Republic of the Philippines  
**GOVERNMENT PROCUREMENT POLICY BOARD**  
**TECHNICAL SUPPORT OFFICE**

**Project: Procurement of Janitorial Service for the GPPB-TSO New Building**

**Bid Bulletin No.: 01**

Revised Plans

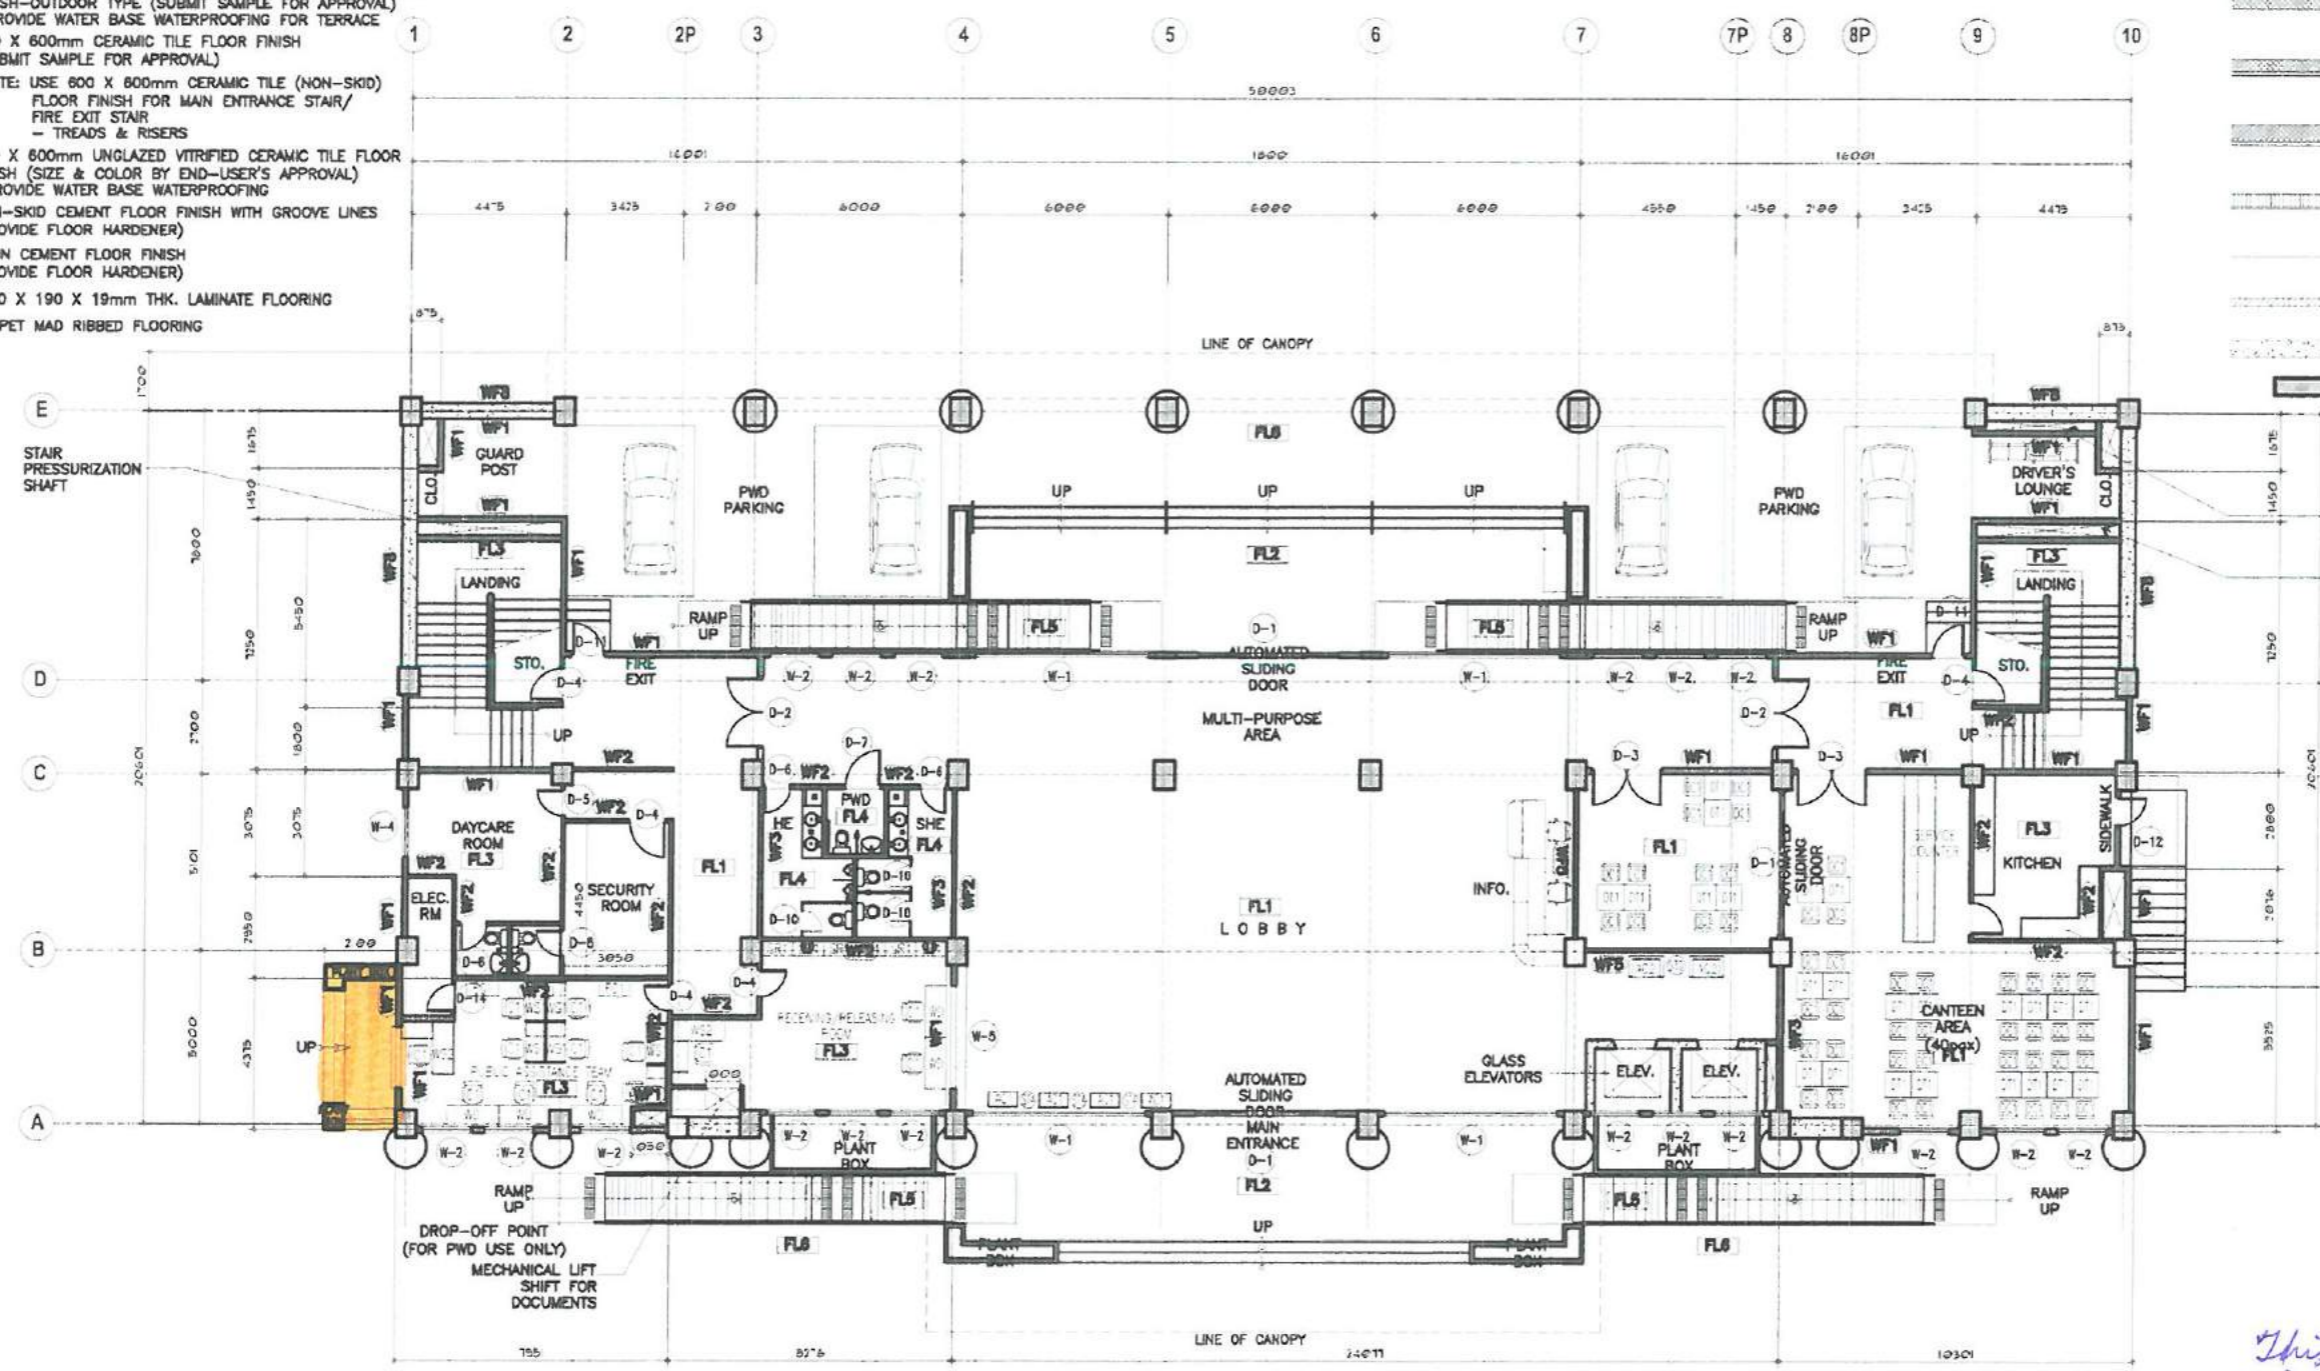
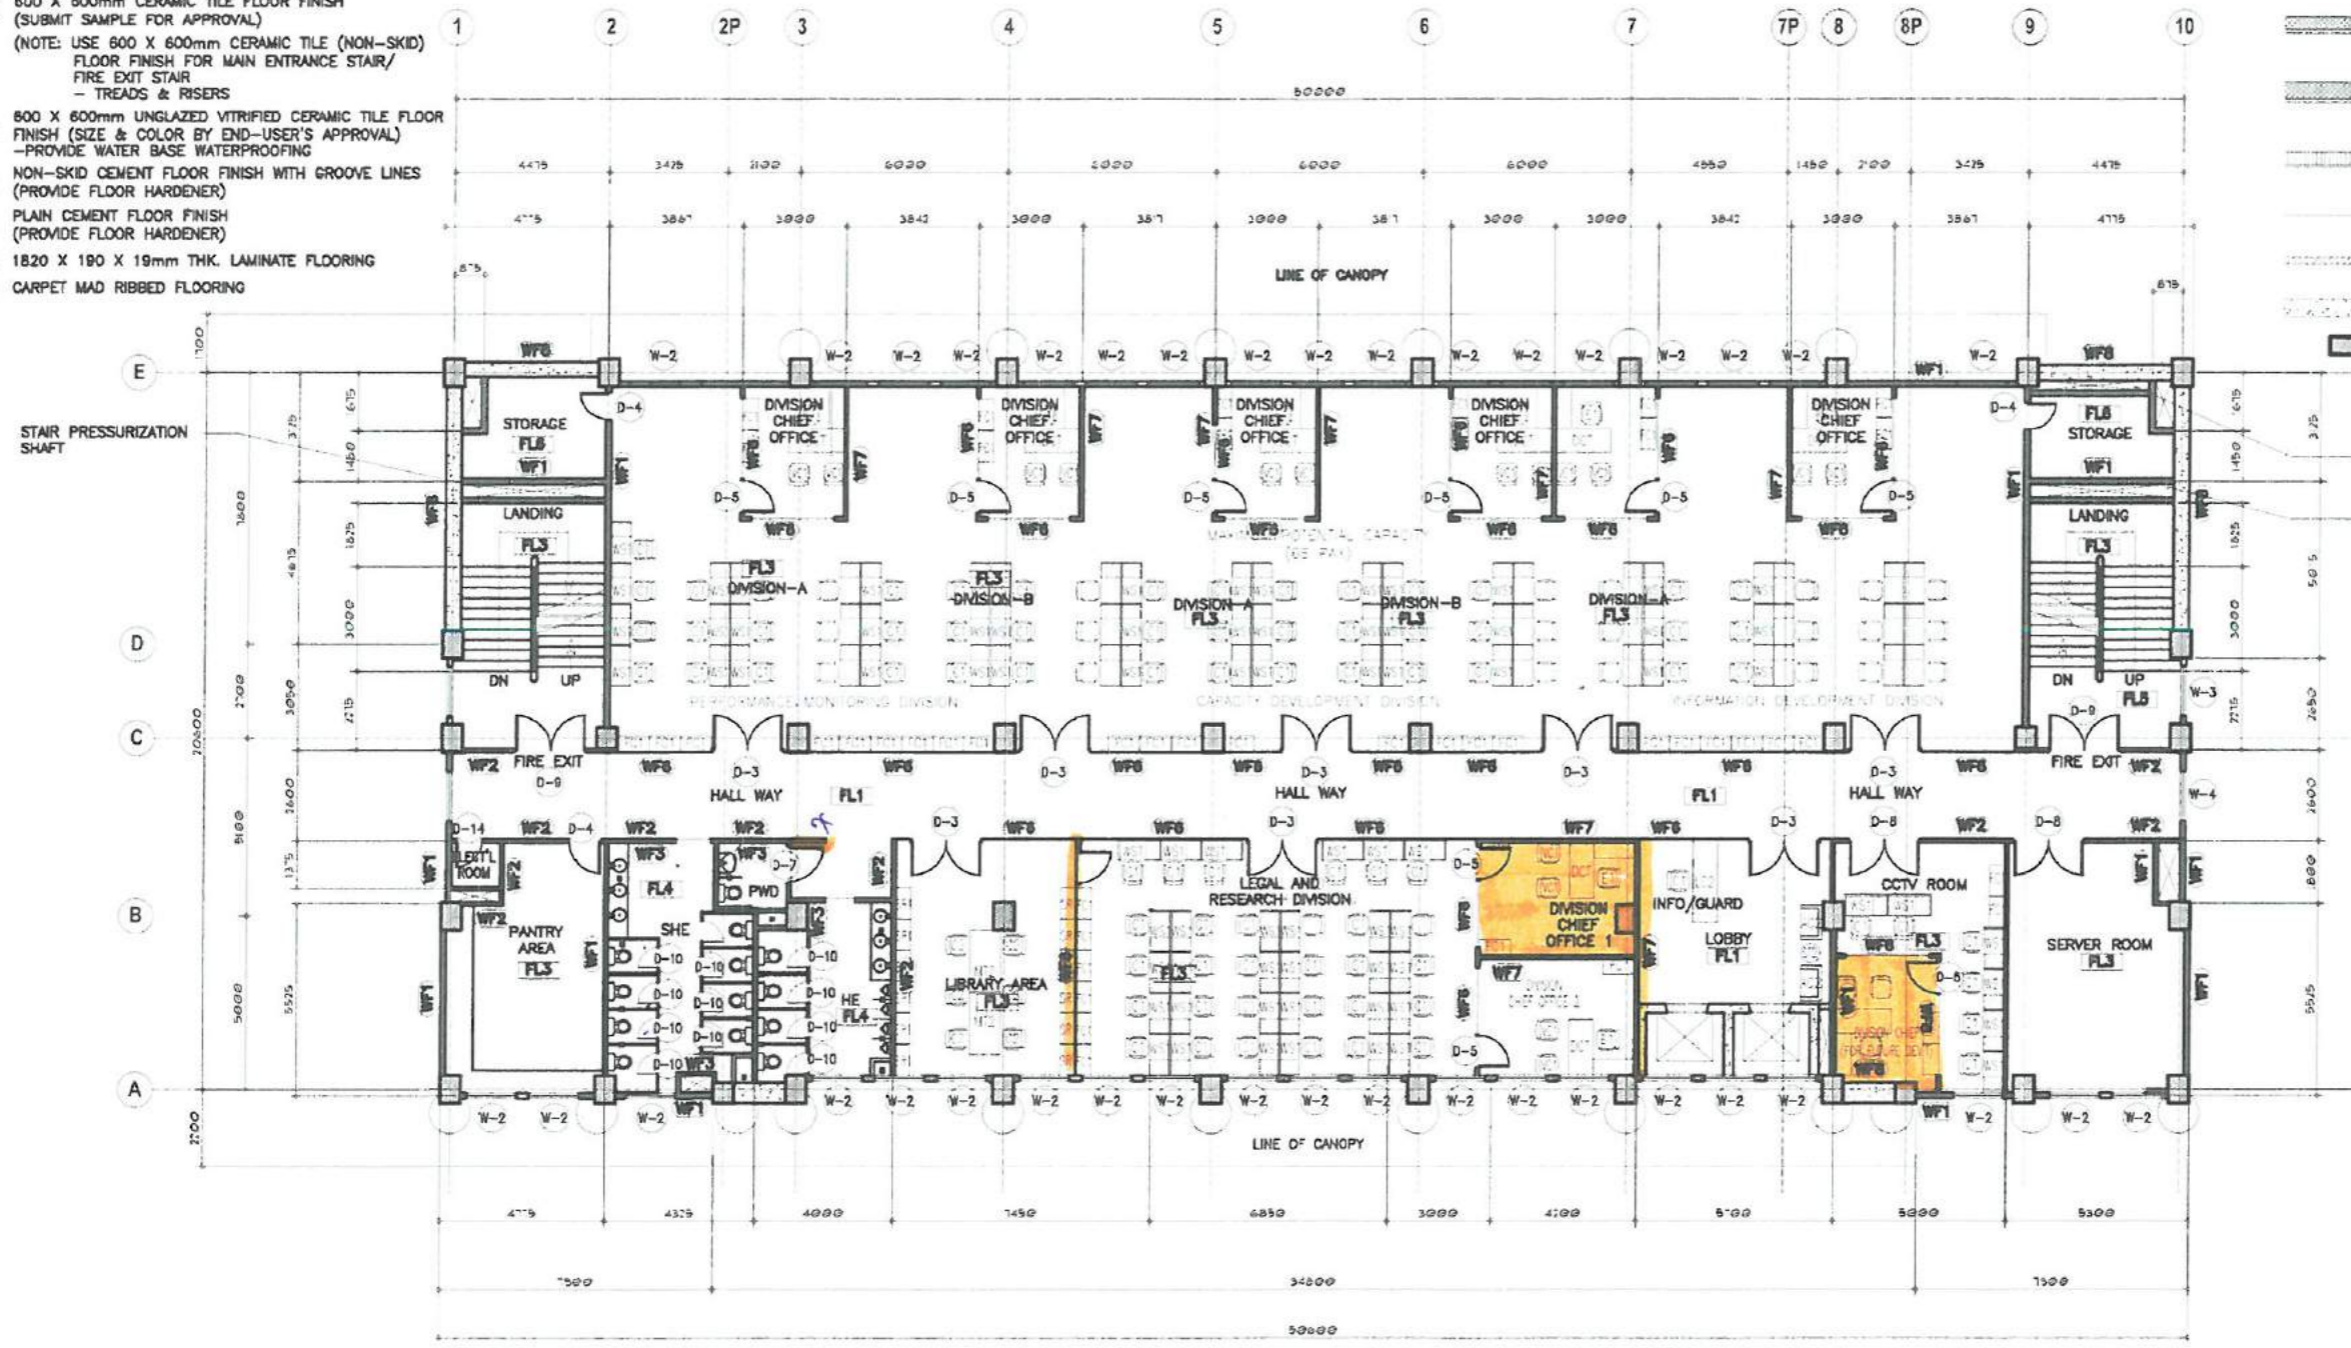
<b>Questions/Concern on the requirements</b>	<b>Clarifications/Answers</b>
1. How many floors are there in the building and how many rooms are there per floor?	There are seven (7) floors in the building and each floor has various number of rooms.  First floor: 12 rooms Second floor: 20 rooms Third floor: 15 rooms Fourth floor: 19 rooms Fifth floor: 16 rooms Sixth floor: 19 rooms Seventh floor: 9 rooms  Please note that enclosed spaces such as storage areas and stairs were counted as rooms. Kindly see attached floor plan reference.
